northern beaches council
PLANS APPROVED BY THE LAND AND ENVIRONMENT COURT OF NSW
PROCEEDINGS NO: 2023/238892
DATED: 5 June 2024

FOR S4.55 (8) APPLICATION

PROJECT:
PROPOSED SENIORS LIVING
4 ALEXANDER ST, COLLAROY
NSW

northern beaches council
PLANS APPROVED BY THE LAND AND ENVIRONMENT COURT OF NSW
PROCEEDINGS NO: 2023/238892
DATED: 5 June 2024

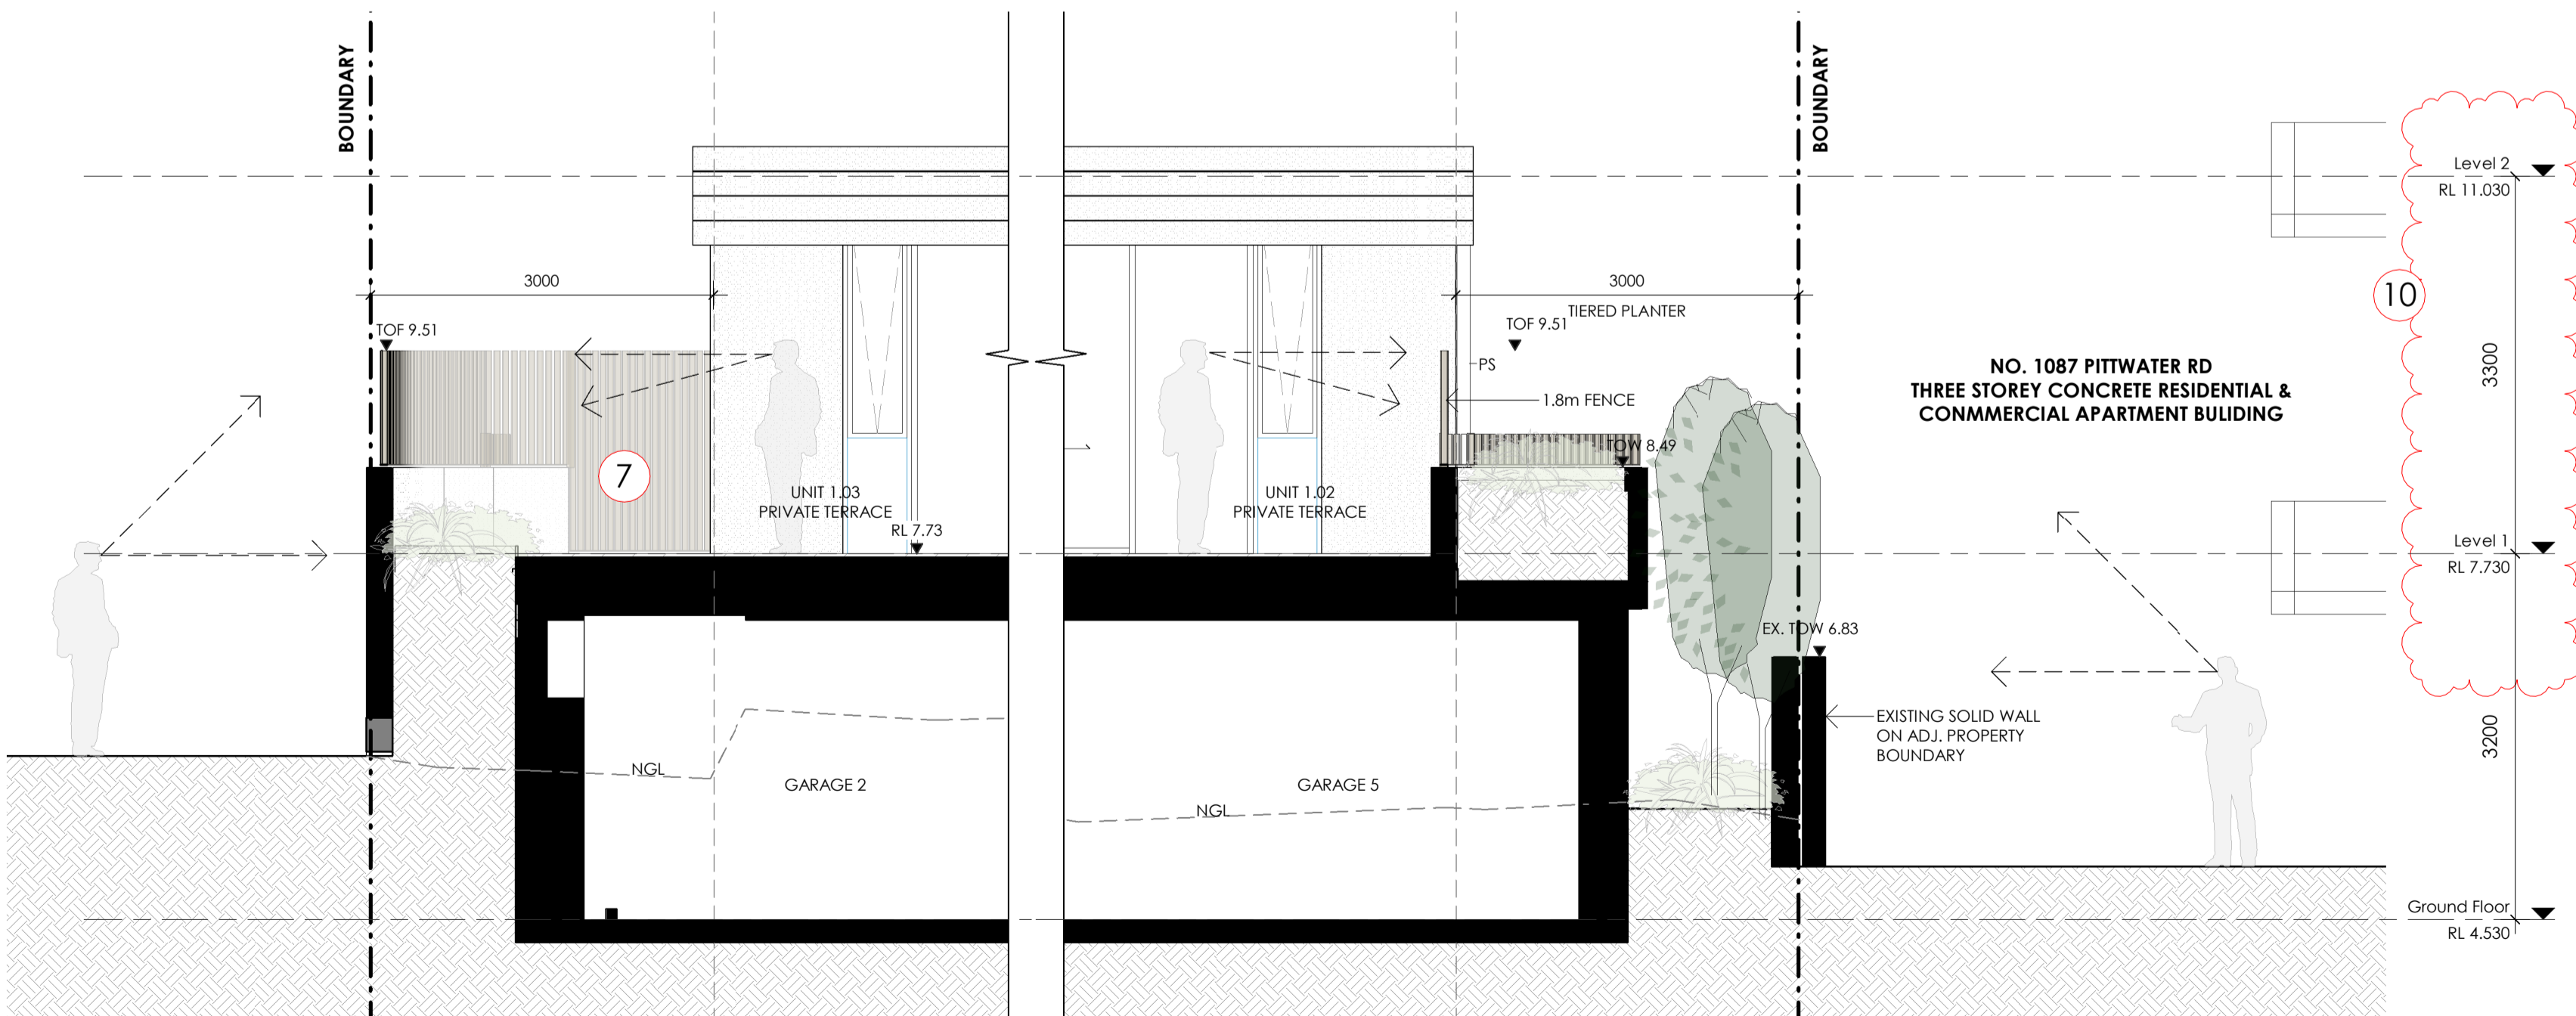
- Proposed modifications to skylights including deletion of 2 skylights over unit 2.01, and updated sizes of skylights over Unit 1.02 & 1.03.
- Additional storage room at basement level.

- Updated interior layout generally.
- Modification to facade windows openings and configurations generally.
- Additional metal framed louvre awning to Level 2.

- Proposed removal of flood gate from driveway and associated DA Condition 28.
- Proposed external design modifications including additional BBQ benches, planters, fences and gates for maintenance access to side planters at rear (Level 1).

- Updated stormwater concept design.
- Associated landscape design update including:
 - a) Level 1: proposed updated overland flow path based on civil eng.'s assessment

- b) Level 1: proposed 2 additional private plunge pools at rear
 - c) Level 1: Revised boundary fencing height and design at rear
 - d) Level 1: Revised external levels

- e) Level 1: Revised external backyard
 - f) Ground floor: Revised front garden design to G.01 and around OSD tank area
- Proposed building height increase including adjustments to floor levels to:

- Level 1: RL 7.73
 - Level 2: RL 11.03
 - Roof: RL 14.25
- Updated roof layout including adjustment to lift overrun structure, services layout and photovoltaic panels. Proposed deletion of DA Condition 8 as part of the proposed amendments at roof level.

- Updated extent of shoring and retention generally.
- Modification to proposed car parking arrangement and number of car space.
- Adjustment to level 2 envelope shifting towards west generally.

- Frosted glazing to level 2 ensuite window
- Proposed removal of topmost roof overhang and revision to the perimeter parapet detail.
- Amended landscape design at level 2 including additional planters and increase southern edge to 1m width.

- Privacy screen to eastern edge of level 2 balcony at rear.
- Updated overland flow path design.
- Updated lift overrun level.
- Updated roof layout to relocate AC units to lower levels.

- Updated fence height to southern boundary
- Proposed 300mm shoring wall setback from boundary with additional planters to landscape architect's details

SECTION A
1 : 100@A1

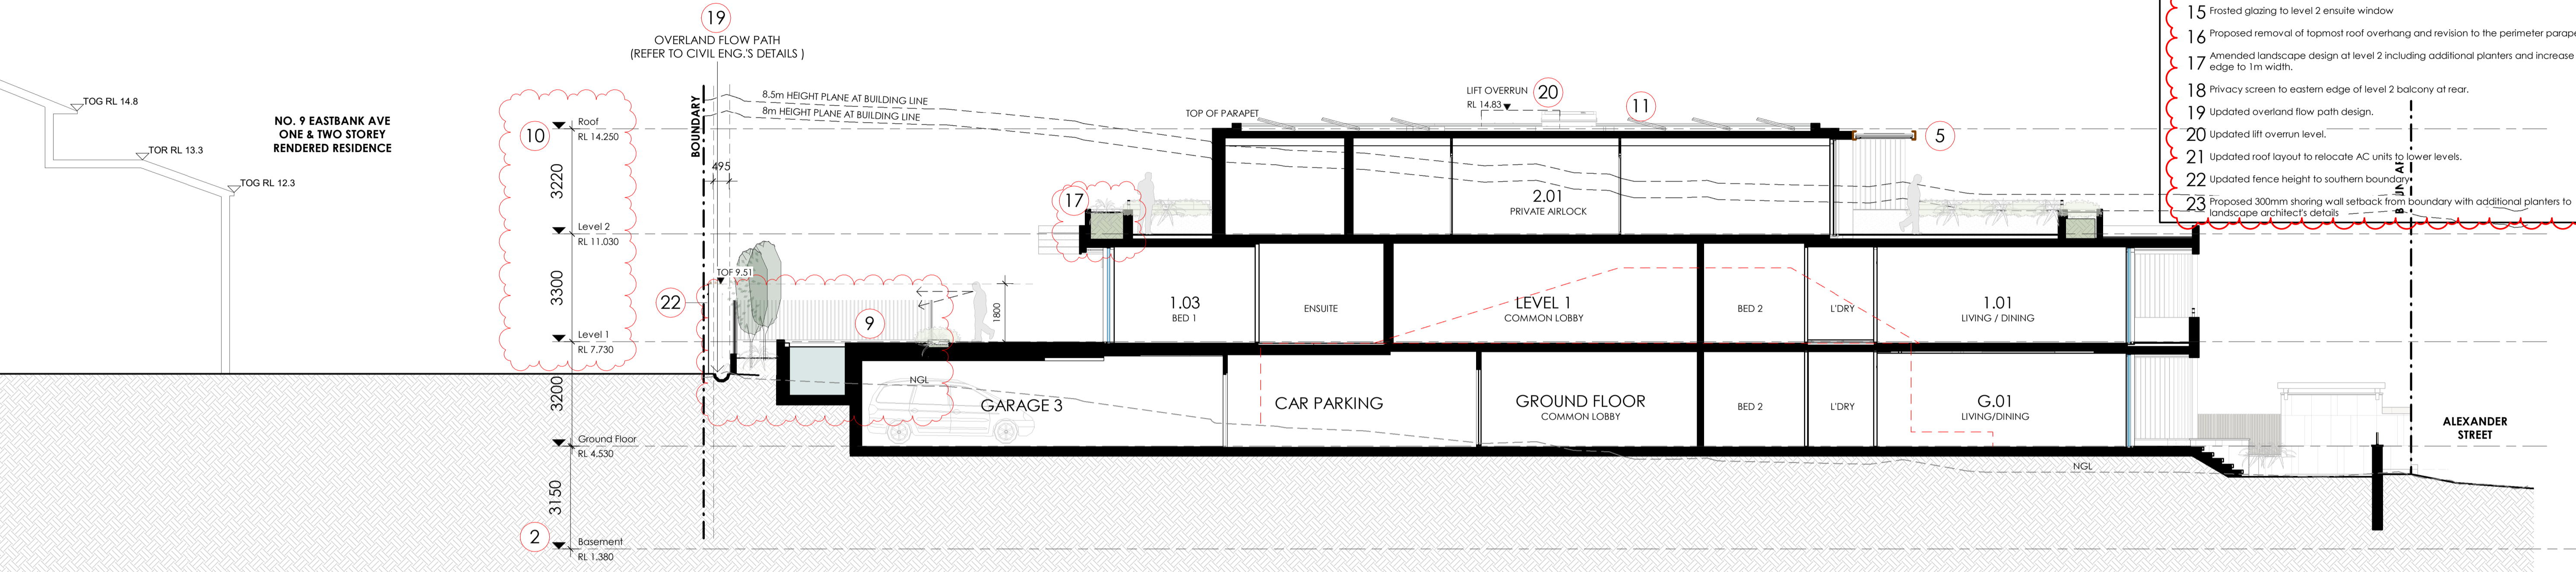
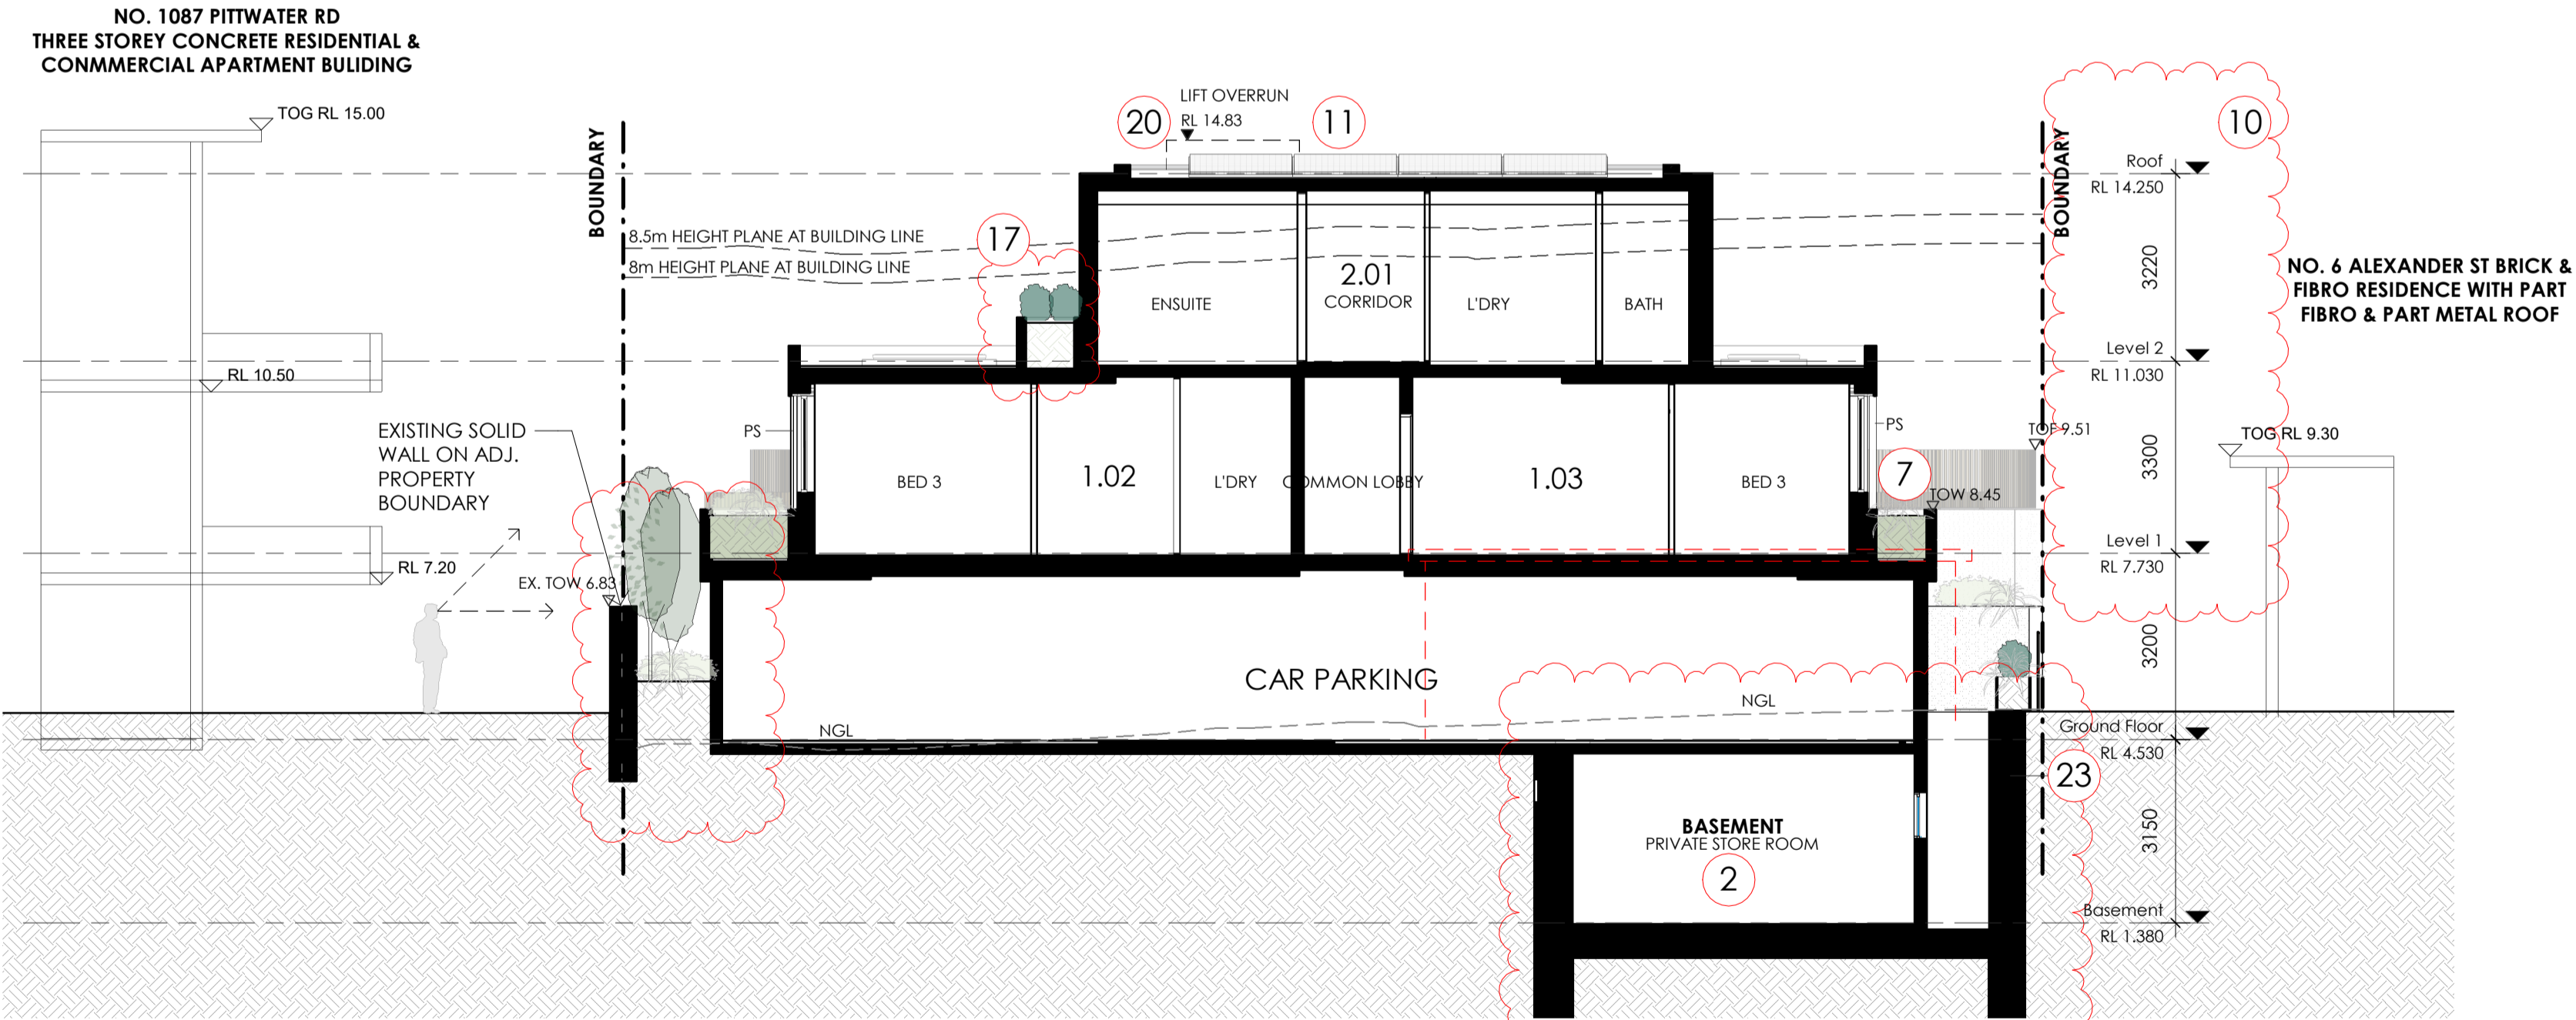
- PROPOSED MODIFICATION ITEM NO. REFER TO LIST BELOW
- Proposed modifications to skylights including deletion of 2 skylights over unit 2.01, and updated sizes of skylights over Unit 1.02 & 1.03.

- Additional storage room at basement level.
- Updated interior layout generally.
- Modification to facade windows openings and configurations generally.

- Additional metal framed louvre awning to Level 2.
- Proposed removal of flood gate from driveway and associated DA Condition 28.
- Proposed external design modifications including additional BBQ benches, planters, fences and gates for maintenance access to side planters at rear (Level 1).

- Updated stormwater concept design.
- Associated landscape design update including:
 - a) Level 1: proposed updated overland flow path based on civil eng.'s assessment

- b) Level 1: proposed 2 additional private plunge pools at rear
 - c) Level 1: Revised boundary fencing height and design at rear
 - d) Level 1: Revised external levels

- e) Level 1: Revised external backyard
 - f) Ground floor: Revised front garden design to G.01 and around OSD tank area
- Proposed building height increase including adjustments to floor levels to:

- Level 1: RL 7.73
 - Level 2: RL 11.03
 - Roof: RL 14.25
- Updated roof layout including adjustment to lift overrun structure, services layout and photovoltaic panels. Proposed deletion of DA Condition 8 as part of the proposed amendments at roof level.

- Updated extent of shoring and retention generally.
- Modification to proposed car parking arrangement and number of car space.
- Adjustment to level 2 envelope shifting towards west generally.

- Frosted glazing to level 2 ensuite window
- Proposed removal of topmost roof overhang and revision to the perimeter parapet detail.
- Amended landscape design at level 2 including additional planters and increase southern edge to 1m width.

- Updated fence height to southern boundary
- Proposed 300mm shoring wall setback from boundary with additional planters to landscape architect's details
